# Sunrise Project

## Project Execution Plan Modification

Submissions Report

**Figure 4**  
**Summary of Approved and Modified Accommodation Demand and Existing Accommodation Supply**

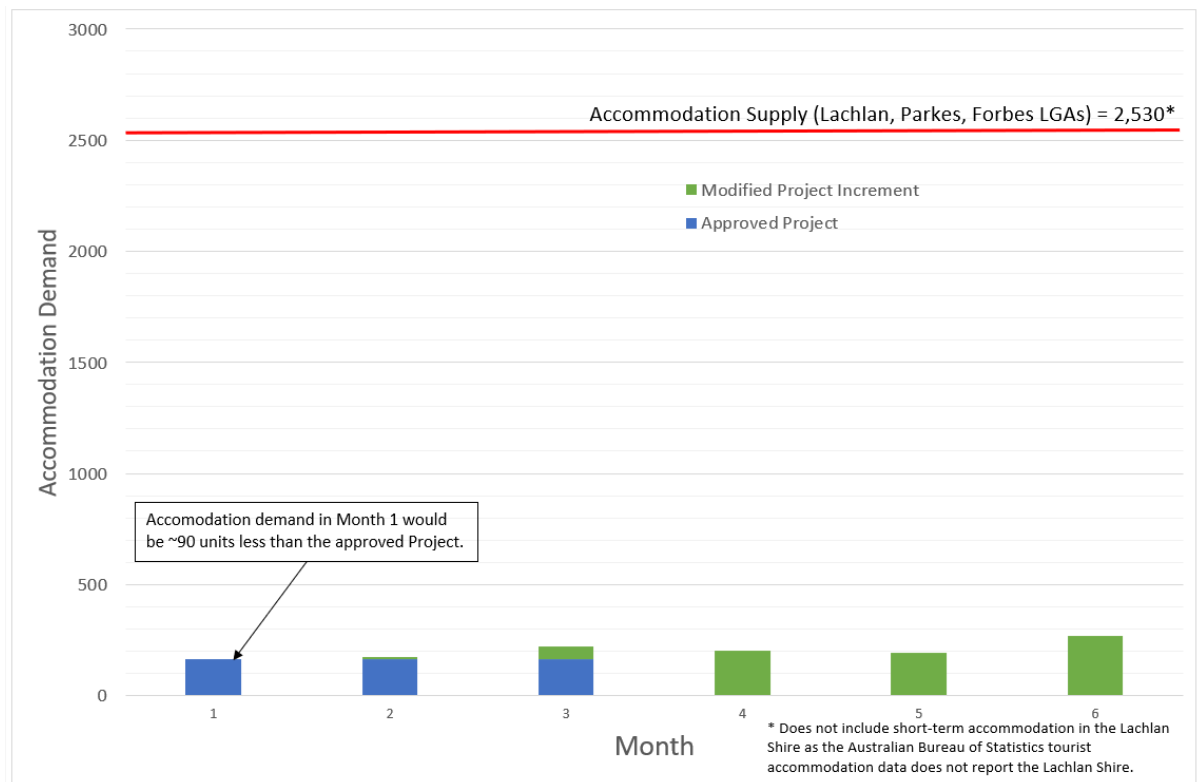
The LSC raised concerns regarding the potential incremental housing availability impacts during the initial construction phase of the modified Project.

The Modification would increase the duration of the period where the accommodation camp would not be available (as it is being constructed) from approximately three months to six months. During this initial construction phase, the Project construction workforce size would average 211 personnel and peak at approximately 300 personnel (Section 4.1.1 of the Social Impact Review).

A summary of the approved and modified accommodation demand over the initial construction phase when the accommodation camp would not be available is provided on Figure 4. The modified accommodation demand would vary month to month in line with the modified Project construction workforce (Figure 4). The modified accommodation demand (i.e. 190 accommodation units) would be approximately 25 units higher than the approved accommodation demand (i.e. 165 accommodation units) on average.

This average incremental demand represents approximately 1% of the total short-term accommodation and rental accommodation supply in the Lachlan, Parkes and Forbes Shires, respectively. It is noted that this estimate is conservative as the estimated available short-term accommodation units does not include short-term accommodation in the Lachlan Shire as the Australian Bureau of Statistics tourist accommodation data does not report the Lachlan Shire (Section 4.2.2 of Social Impact Review).

Figure 1 Modelled 99.9<sup>th</sup> percentile H<sub>2</sub>SO<sub>4</sub> due to the processing facility

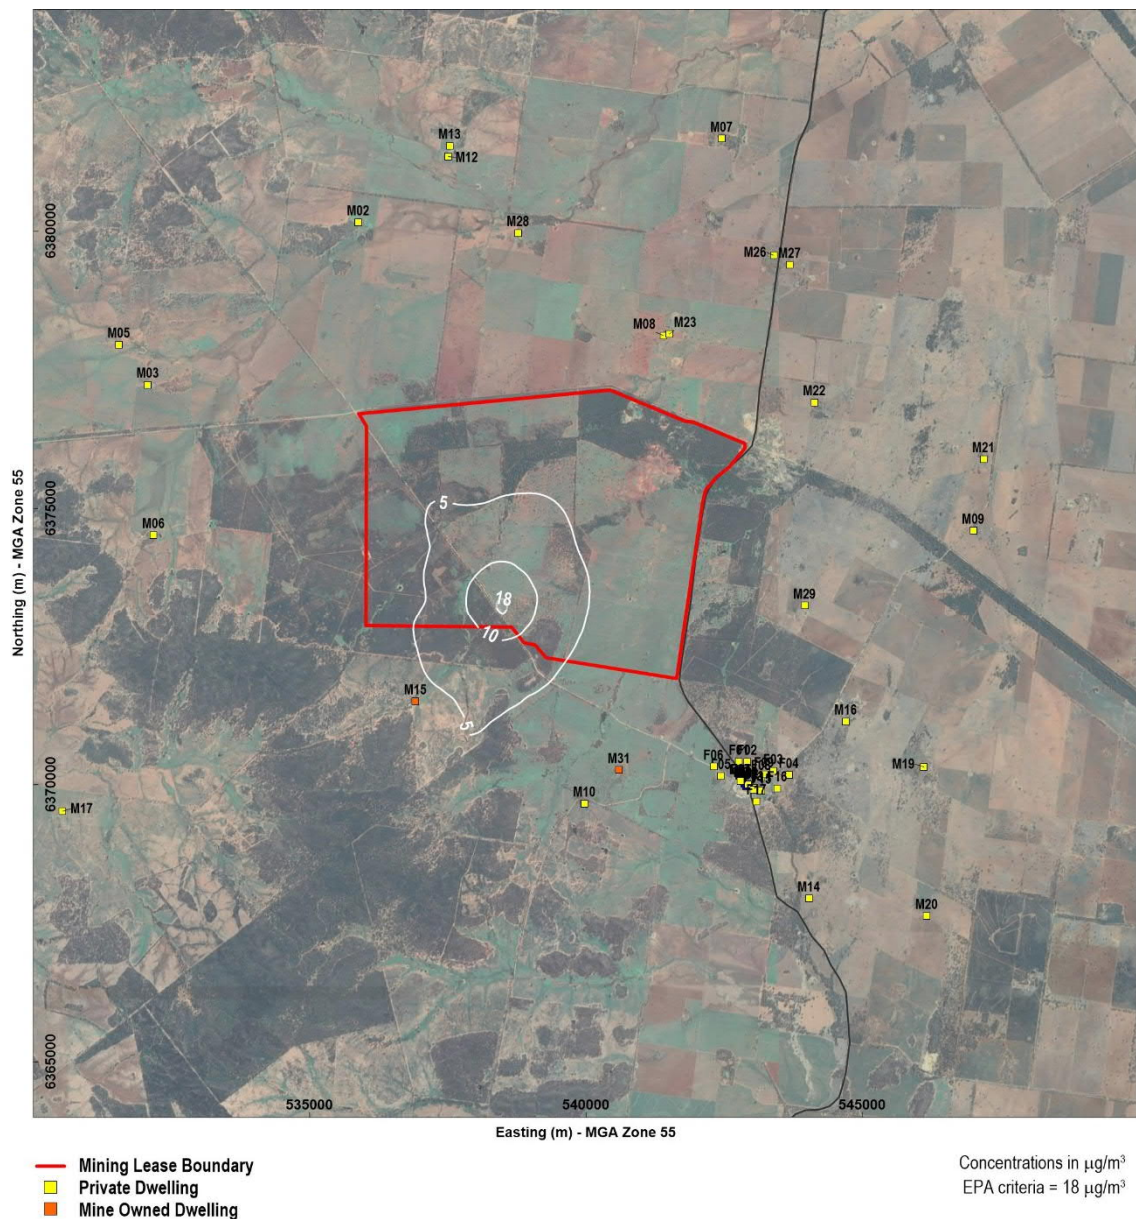
The EPA requested that SEM demonstrate that compliance with the EPA impact assessment criterion for sulphuric acid can be achieved at the site boundary. The EPA recommended that consideration should be given to the assessment of potential impacts based on plant specific emission performance of sulphuric acid emissions.

The potential impacts of sulphuric acid mist in the Modification Air Quality Assessment (Jacobs, 2021) were determined by conservatively modelling the acid plant in-stack concentrations at the limit for scheduled premises under the *Protection of the Environment Operations (Clean Air) Regulation 2010* (POEO Regulation) (i.e. 100 mg/Nm<sup>3</sup>) rather than the current design specifications (i.e. 60 mg/Nm<sup>3</sup>) (Attachment 2).

Figure 1 shows the modelled 99.9<sup>th</sup> percentile H<sub>2</sub>SO<sub>4</sub> concentrations due to the expected processing plant emissions (i.e. 60 mg/Nm<sup>3</sup> of H<sub>2</sub>SO<sub>4</sub>). The relevant EPA impact assessment criterion is 18 micrograms per cubic metre (µg/m<sup>3</sup>), applied at the site boundary (EPA, 2016). It can be seen from these results that the 99.9<sup>th</sup> percentile concentrations of H<sub>2</sub>SO<sub>4</sub> are not expected to exceed 18 µg/m<sup>3</sup> beyond the site boundary. In addition, the highest ground-level concentrations from the model were 18 µg/m<sup>3</sup> and near the processing facility. Therefore, the modified Project would comply with the H<sub>2</sub>SO<sub>4</sub> criteria. The results assume continuous operation of the acid plant and should therefore represent a conservative estimate of impacts.

Figure B.1 – Year 1 Low Frequency Noise Spectra (Receivers M02 to M27)

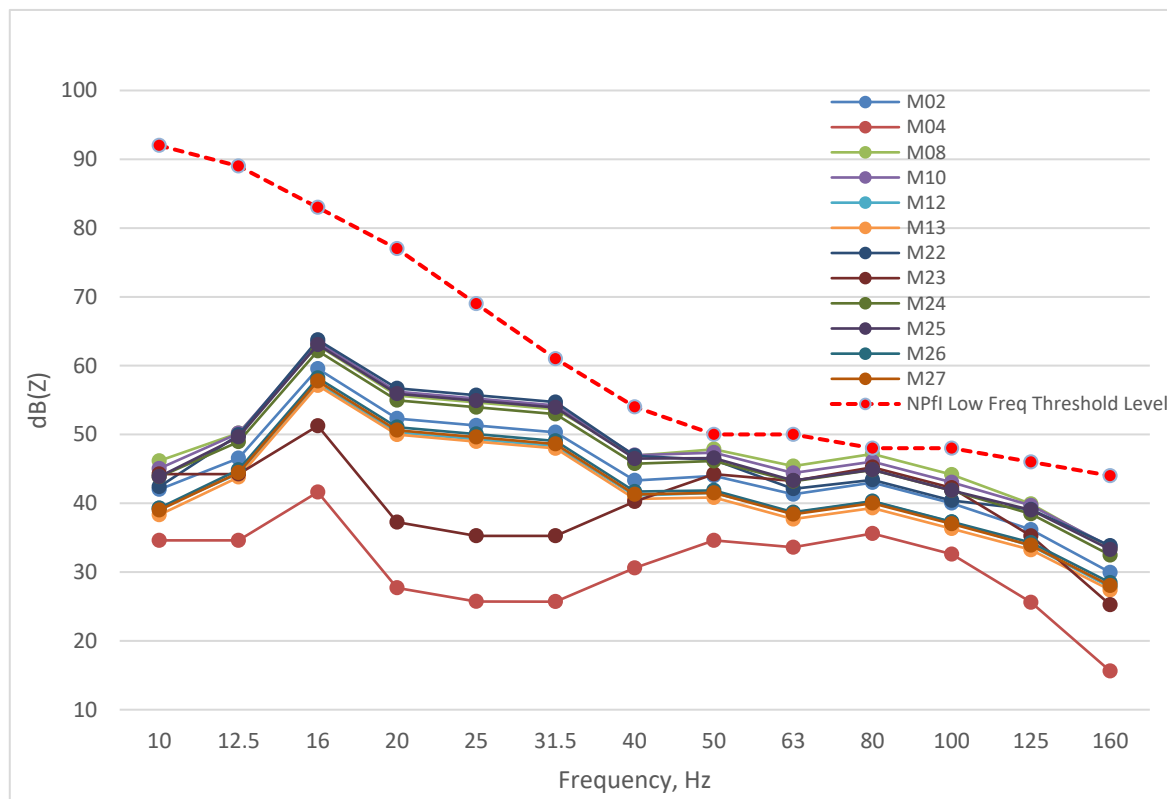
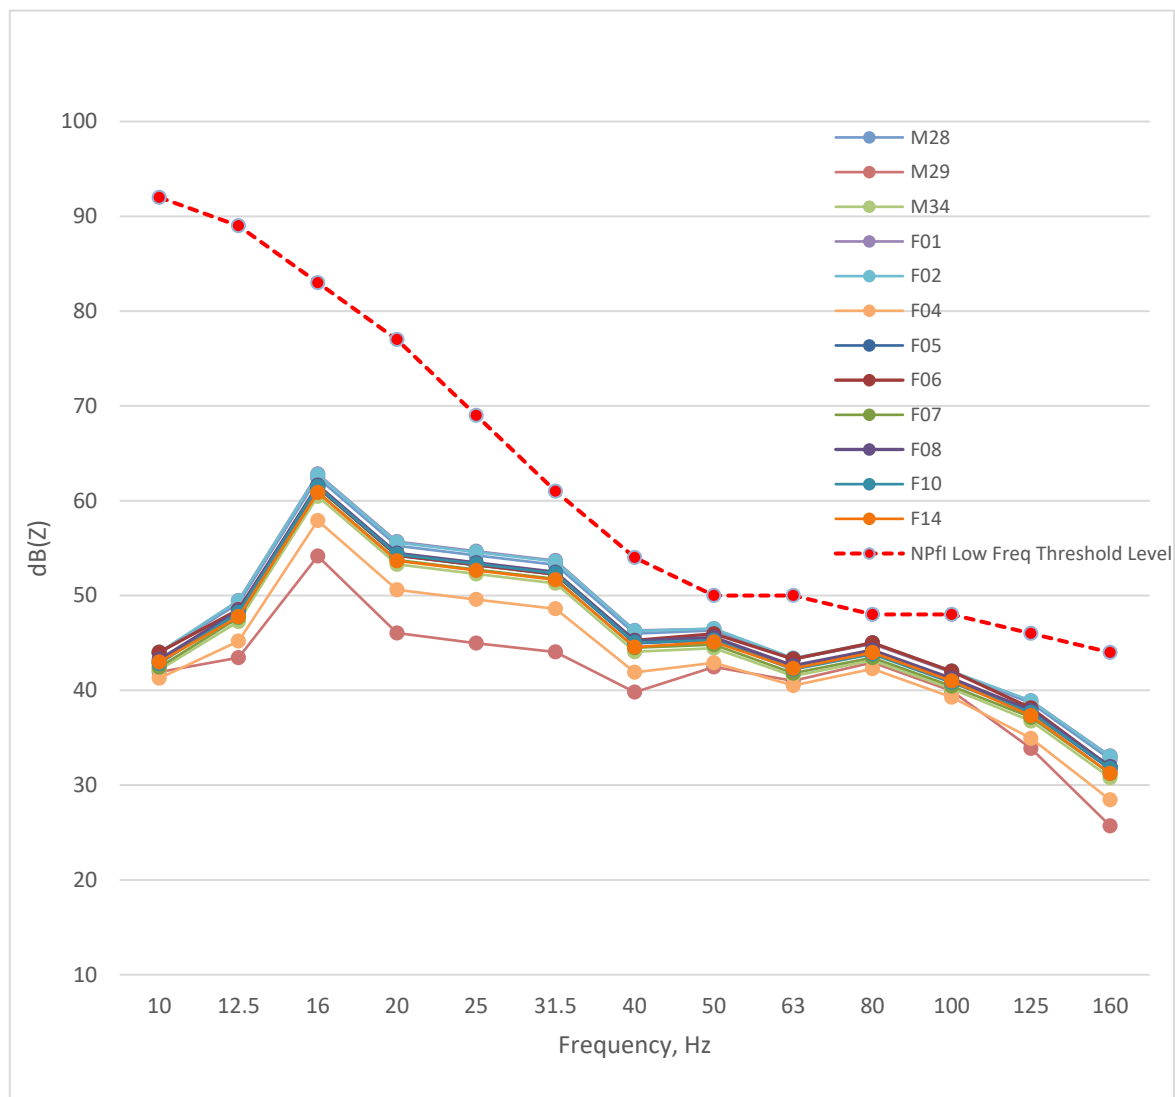
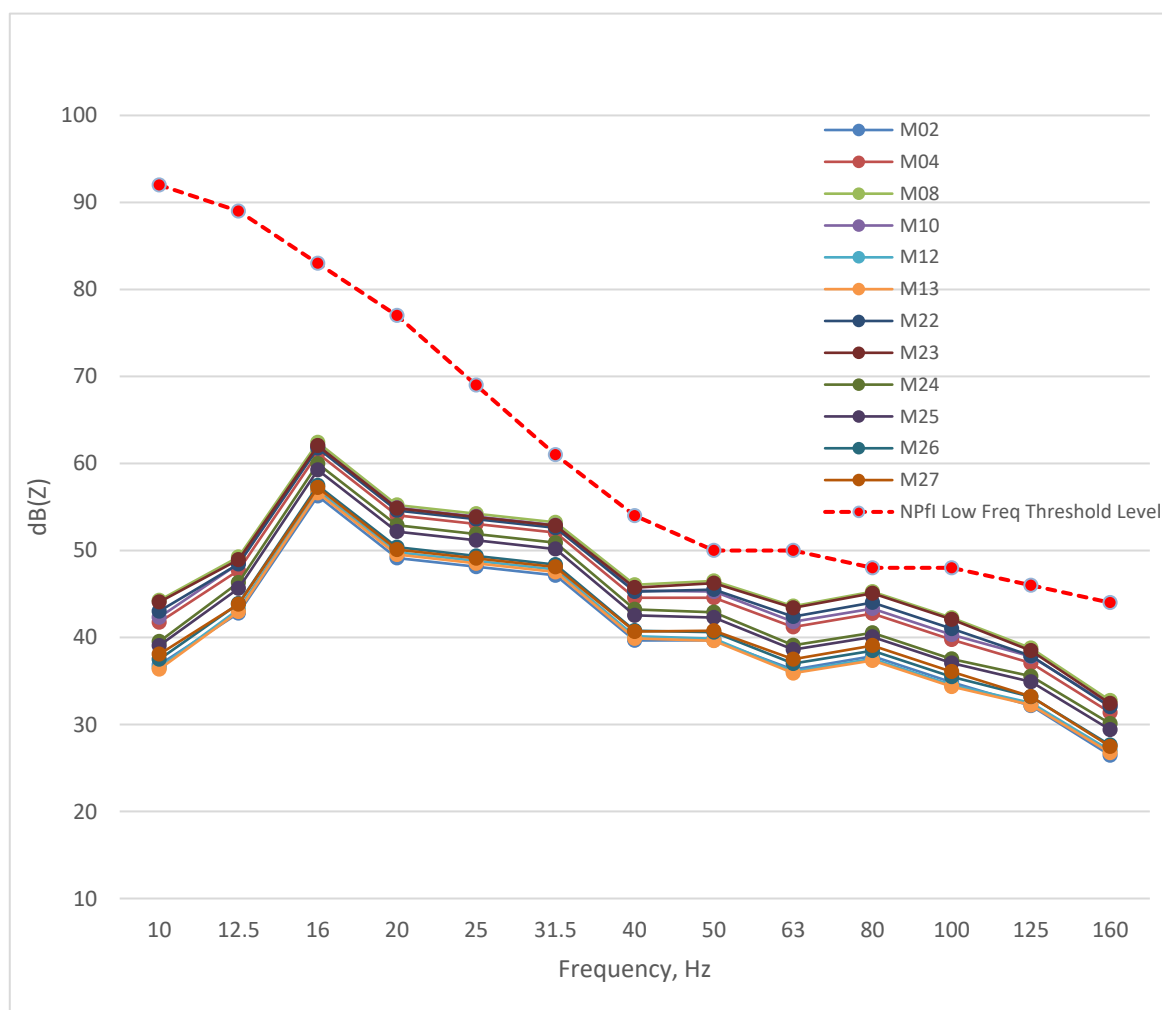
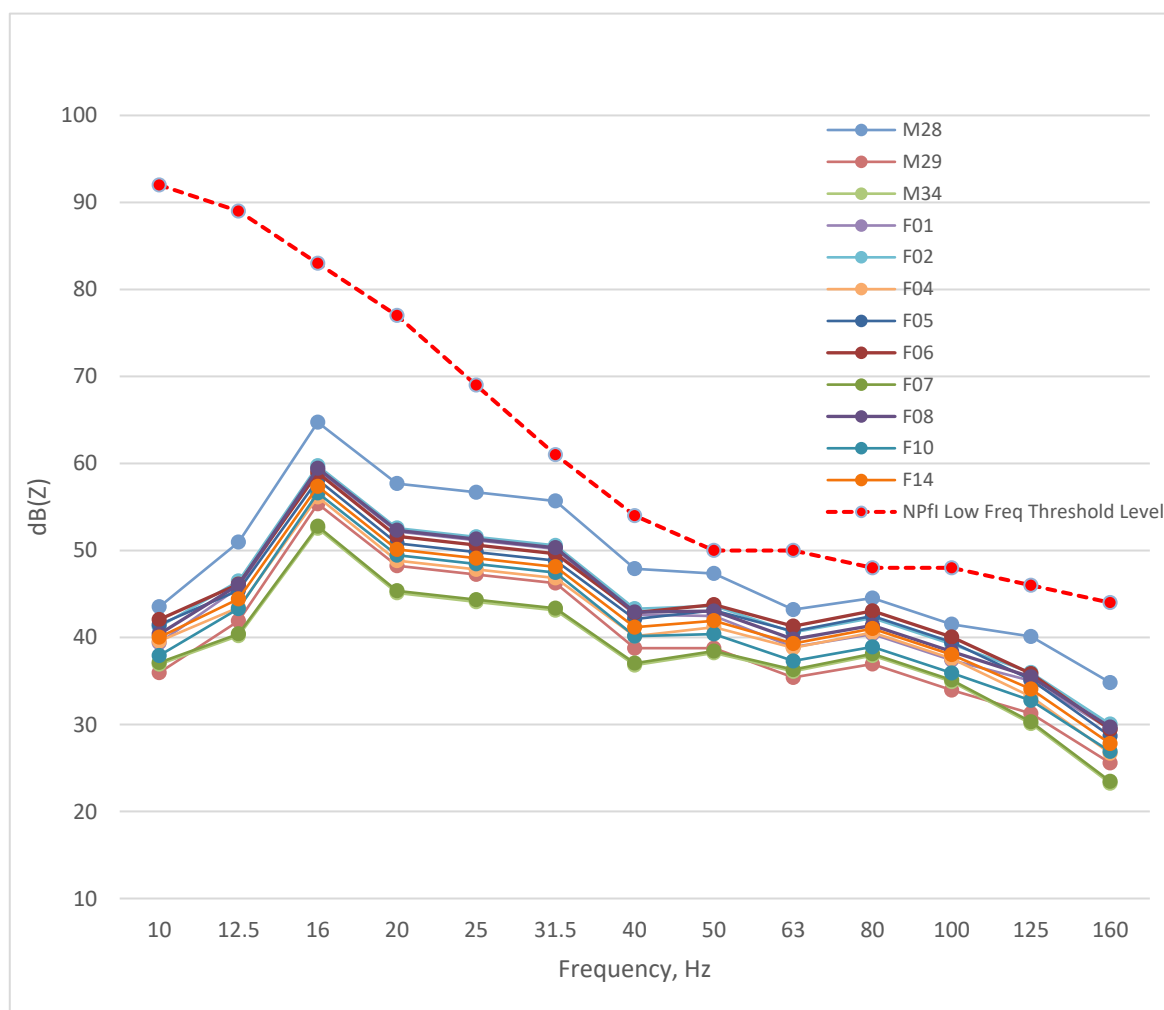
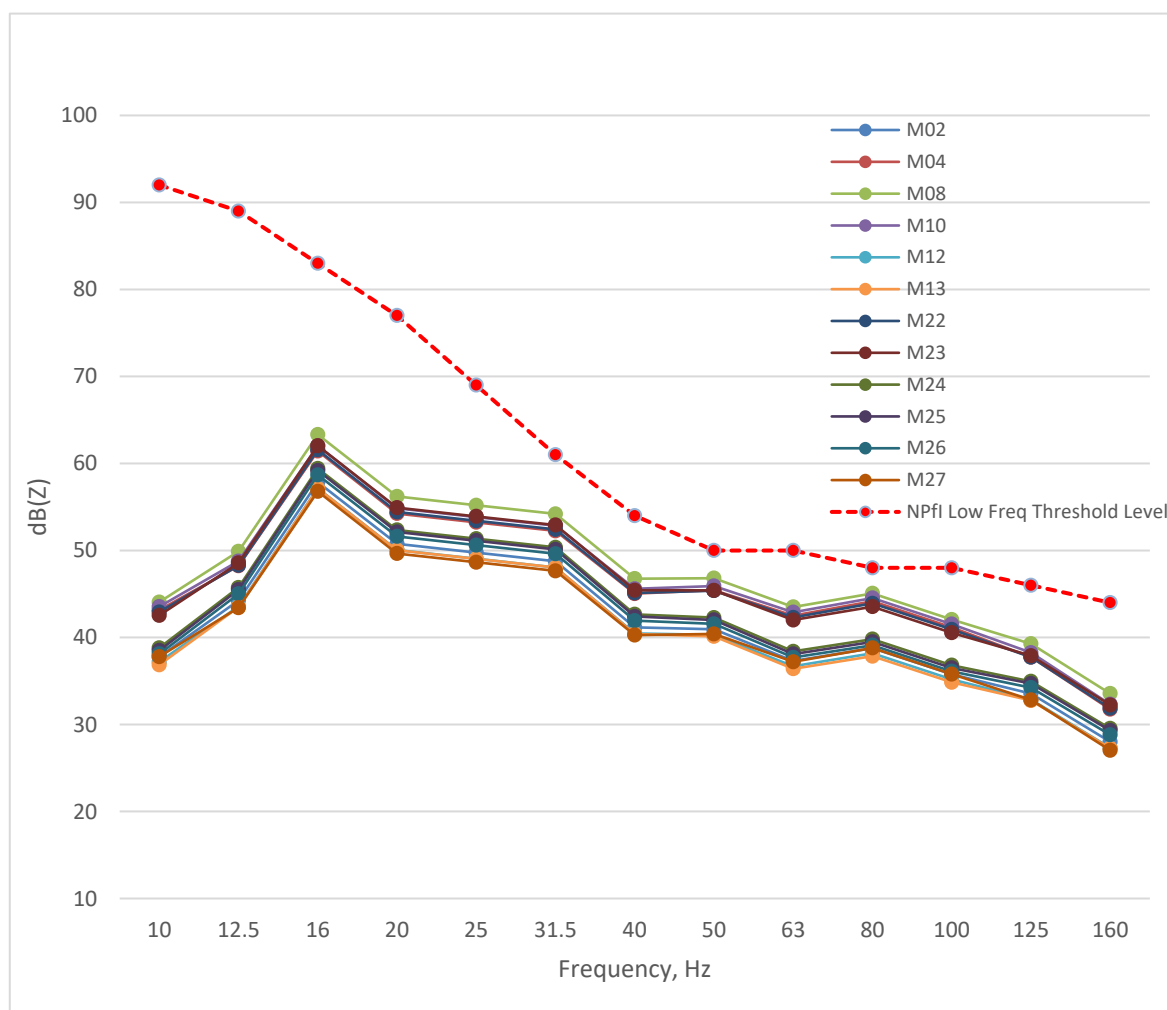
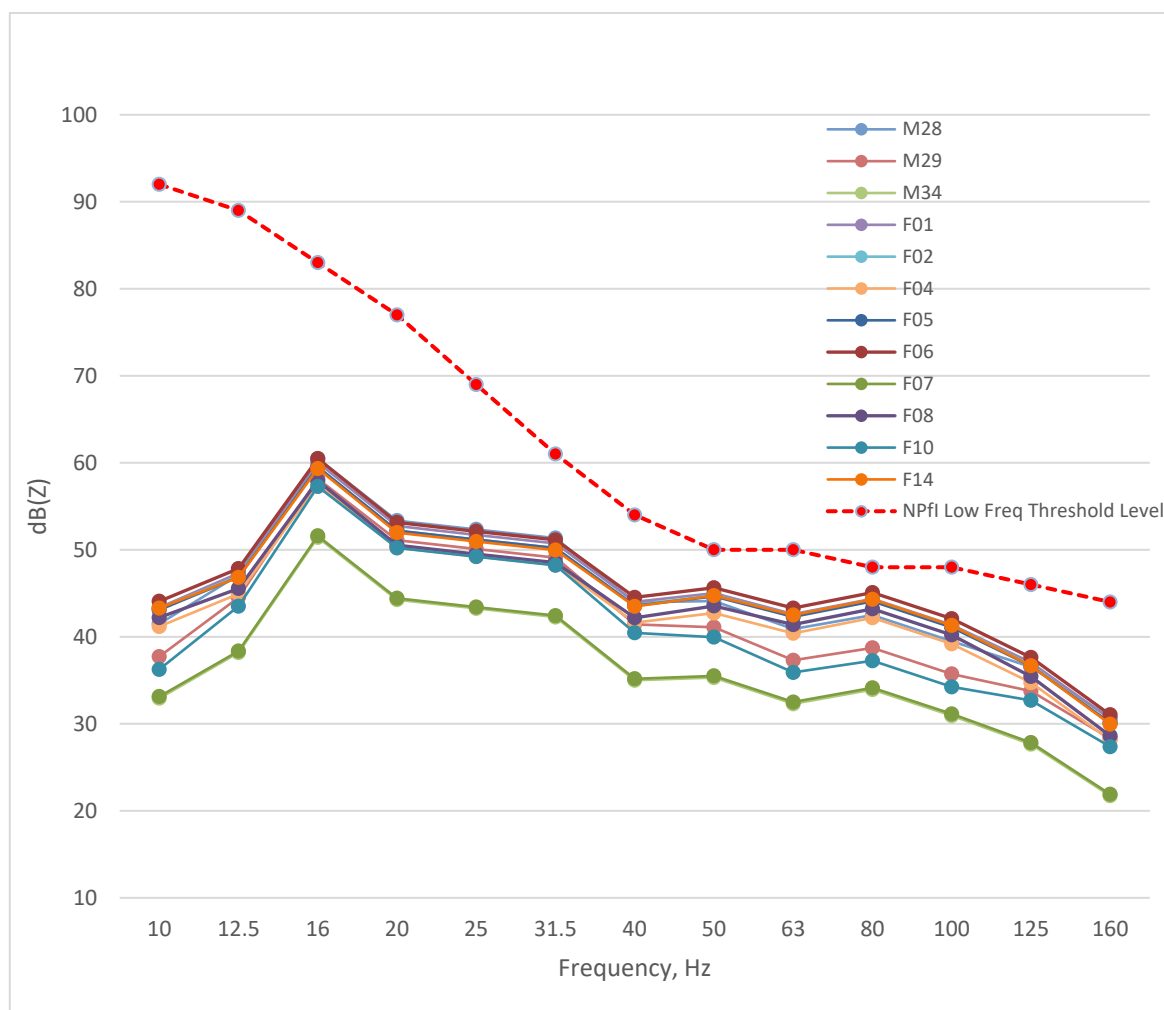
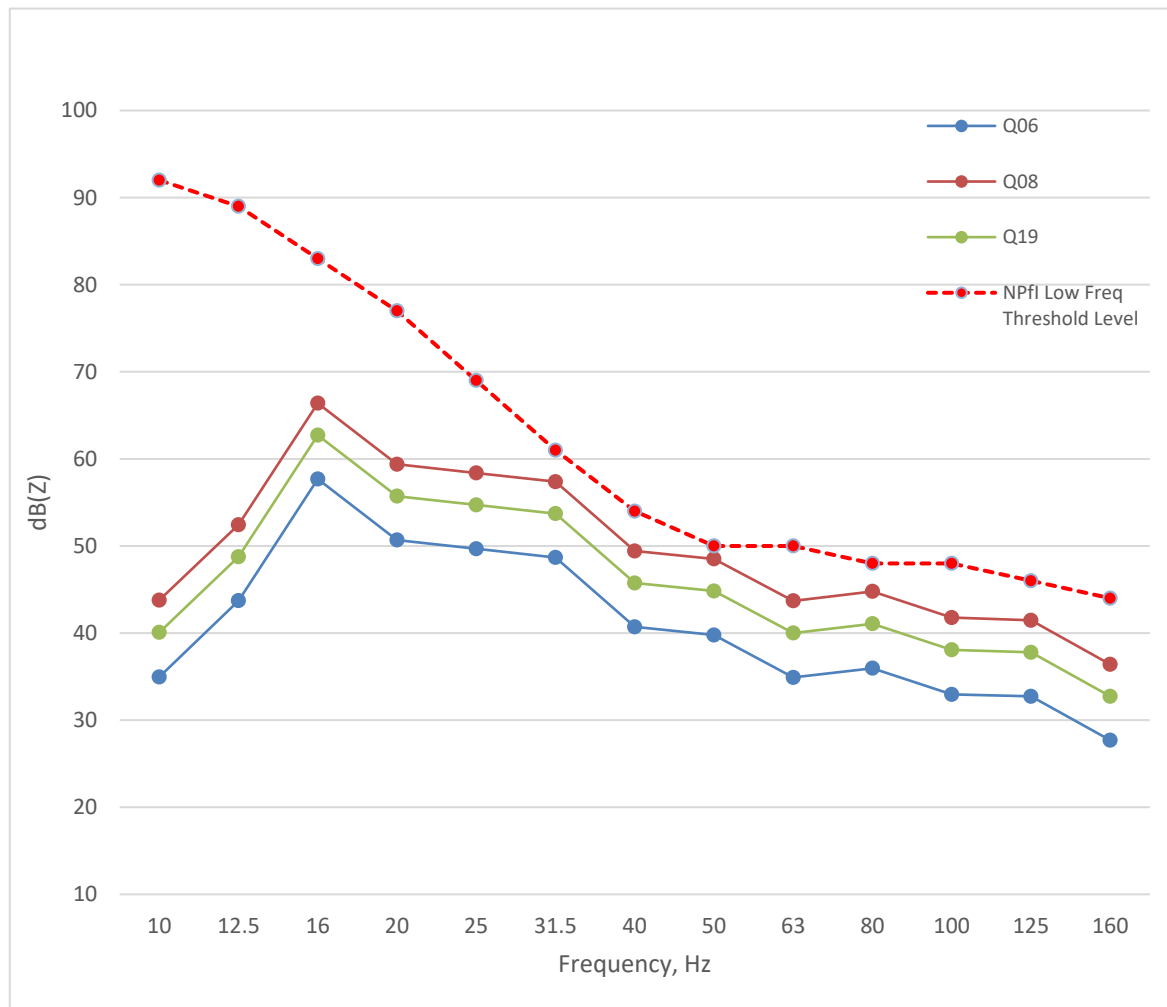
The EPA requested calculations and information to support the assessment of modifying factors in accordance with NPfI Fact Sheet C.

Renzo Tonin has prepared a detailed low frequency noise assessment of the Modification, which includes calculations and noise curves for the assessed receiver locations (Attachment 3).

The low frequency curves show that no privately-owned receiver is expected to experience dominant low frequency noise and therefore no modifying factor corrections are required consistent with the conclusions of the Noise Assessment (Attachment 3).
